Staff Report Memorandum

To: Planning Commission
From: Community Development Department
Subject: Sandy Fire Station #31 (Cairns Site Plan Preliminary Review)
9295 S. Monroe St.
(Community #2, Civic Center)

SPR02132024-006711
RC Zone
Cairns District
2.53 Acres
approx. 34,000 sq. ft. Bldg

Exhibit "A"
– see attachment for the full set of plans –

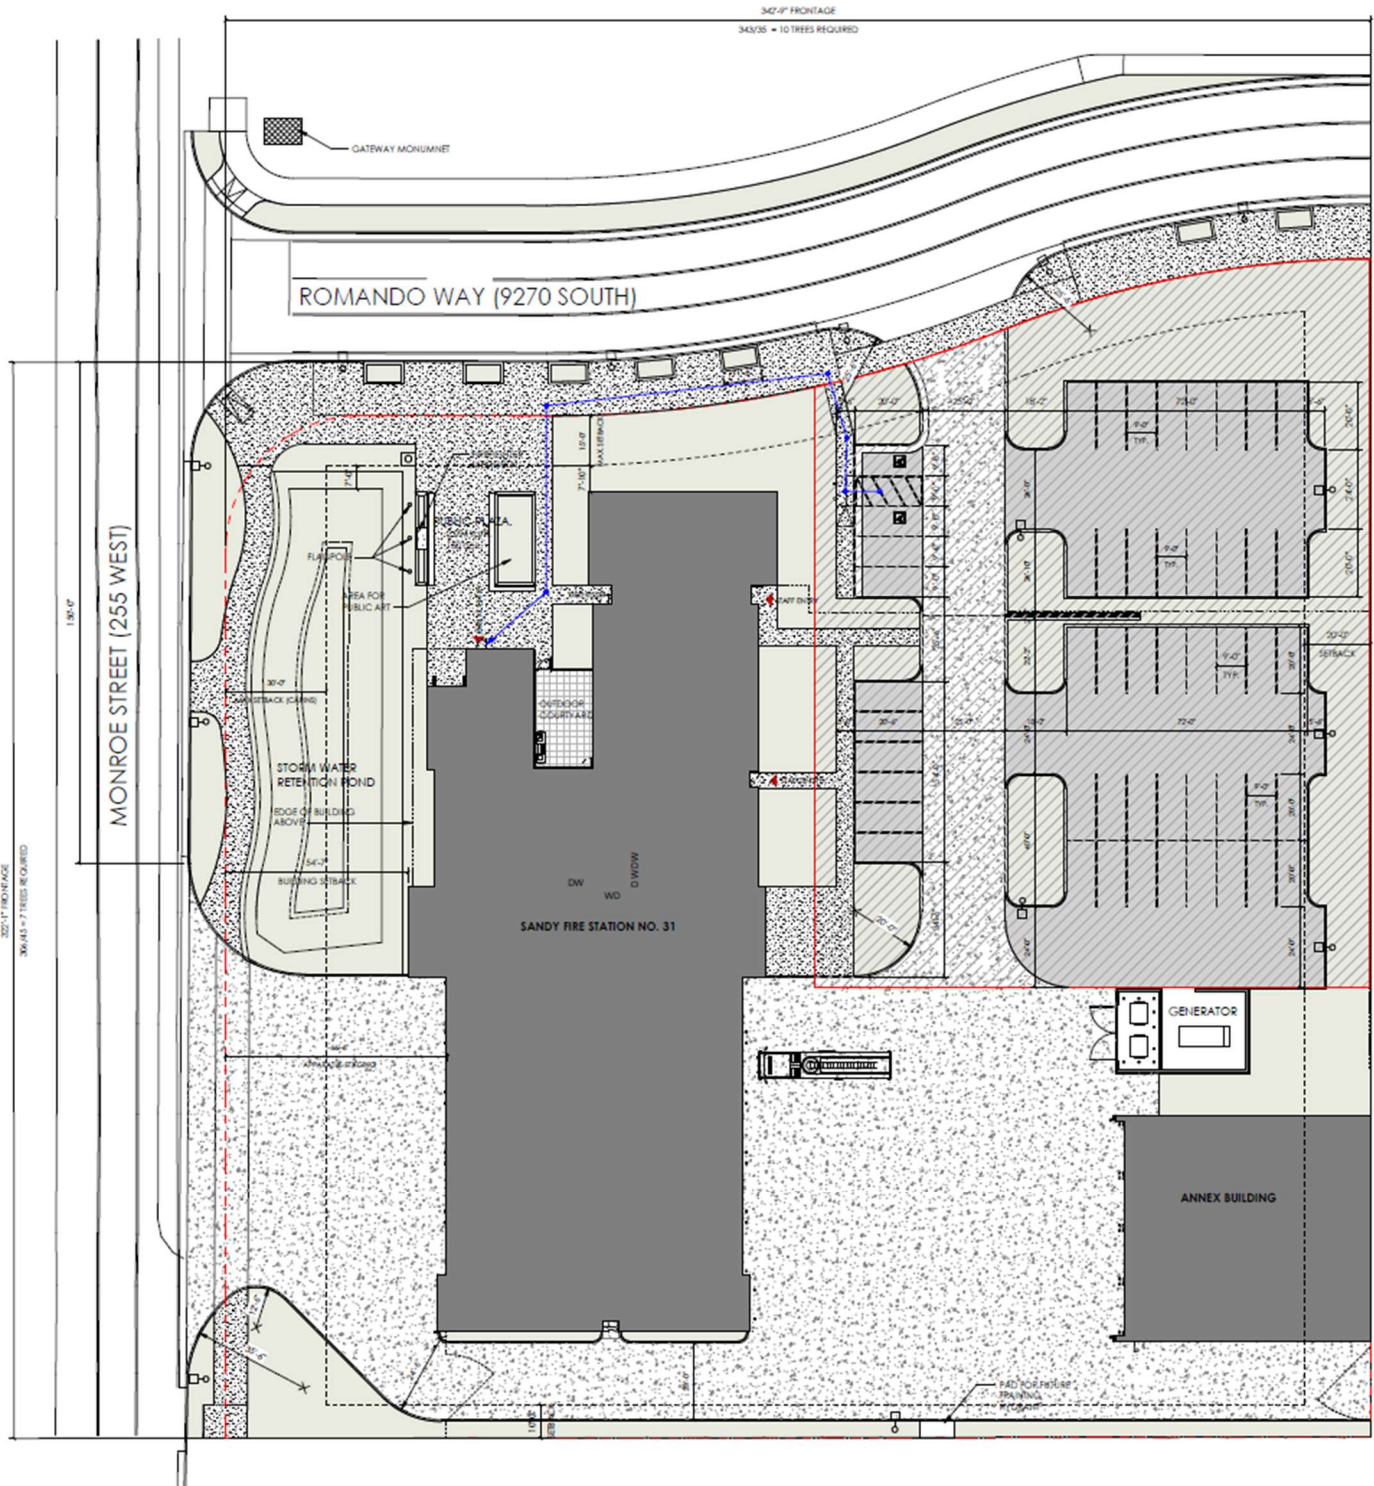
- Building height of less than eight stories and approved to be a minimum of five stories
 - *Within this area of the Cairns, the master plan calls for the minimum heights to be 8 stories and above. The intent of this is to take advantage of the freeway frontage with taller buildings that would create a presence and focal point of this urban village.*
- 70% of Building Placed within 5' of building setback
 - *The entire building is placed well beyond the minimum setbacks for both streets. This regulation is attempting to*

- Max Building Setback exceeded (both streets)
 - *There is a minimum and maximum setback along each street based on the Street Type. This building is placed 24'7" beyond the maximum setback of 30' along Monroe Street (total setback is 54'7"). Along 9270 South, the building is placed 7'10" beyond the maximum setback of 15 feet (a total setback of 22'10"). The buildings orient to the plaza located near the corner of these streets.*

- Pedestrian Entrances (4 per 200' (Type 2 Street) & 2 per 200' (Type 4 Street))
 - *Only one pedestrian access is provided which is facing 9270 South Street which is accessed through the proposed plaza space. There are no pedestrian accesses along Monroe Street. This regulation is seeking to improve the pedestrian experience and accessibility into the buildings.*

- Surface Parking Facing a Type 2 Street
 - *This street type encourages pedestrian activity and a parking lot adjacent to the street does not contribute to a friendly pedestrian environment in an urban area. It provides no activity or visual interest.*

- Driveway Approach Width for Apparatus Bays
 - *The maximum width of a driveway approach is 24 feet. This is designed to limit the interruptions of the pedestrian paths within Cairns and shorten crossing distances. They are seeking a 94 foot width to allow for the fire apparatus bays to have direct access to the street.*

- Fenestration of base, middle, and top of 50% min glass window/door treatments on all elevations & at least 50% of the ground floor on-street facing walls should include a non-reflective, transparent glass treatment

Staff has noted that the mechanical equipment is not fully screened and will require a secondary screening system. It is also unclear how much window glazing is proposed on the second story as much of that glazing appears to be screened with a metal panel.

- a. building height of less than eight stories and approved to be a minimum of two stories;
 - b. 70% of building placed within 5' of building setback, and approve the placement as shown on the site plan;

- c. max building setback exceeded (both streets) and approve the setbacks as shown on the site plan;
 - d. pedestrian entrances be reduced to one;
 - e. no on-street parking on 9270 South Street be provided;

- f. no ground floor commercial be provided;
 - g. surface parking be allowed to face 9270 South Street;
 - h. surface parking lot be allowed to exceed 10% of overall site;

- i. driveway approach width over 24 feet to allow up to 94 feet;
 - j. building articulation of uninterrupted expanses be approved up to 34 feet; and
 - k. fenestration of base, middle, and top less than 50% and less than 50% non-reflective, transparent glass treatment as shown in the architectural elevations.

10. That the applicant work with staff to determine an appropriate implementation of public art within the plaza area.
11. That the applicant install a secondary screen system for roof mounted equipment that extends above the roof edge.
